Harnett County Government Complex
307 Cornelius Harnett Boulevard
Lillington, NC 27546

RE: Harnett County Land Use Application 05-5-13134R

Option #1

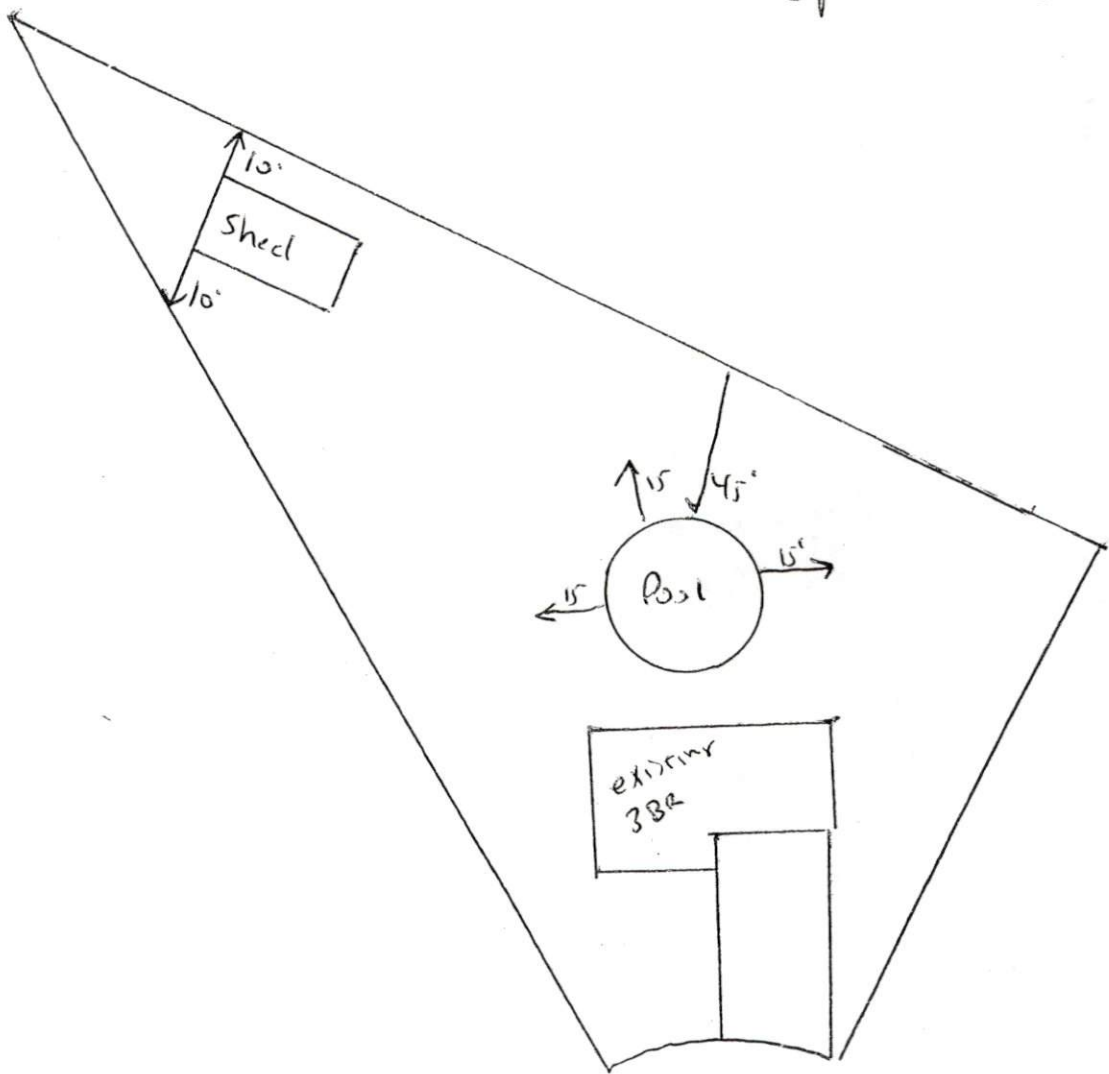
Option #1 is to move the
Pool as shown. No work
on the septic system would be
required - other than fixing any
chambers damaged.

Option # 2

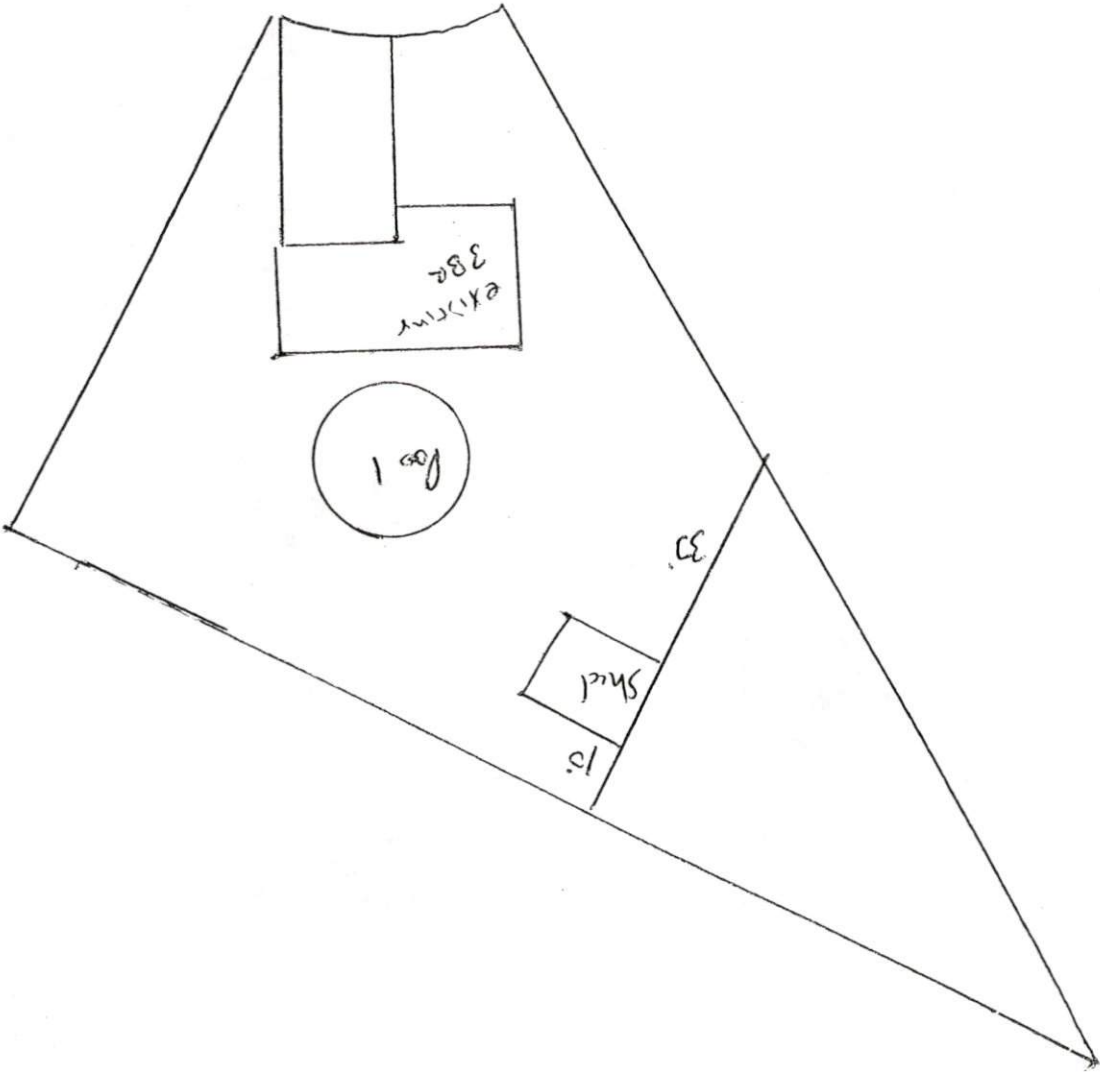
Option # 2
Is to move the Building,
Leave the pool as is and install
a new septic system. This new
septic system would require a
new tank, a pump tank and
new line
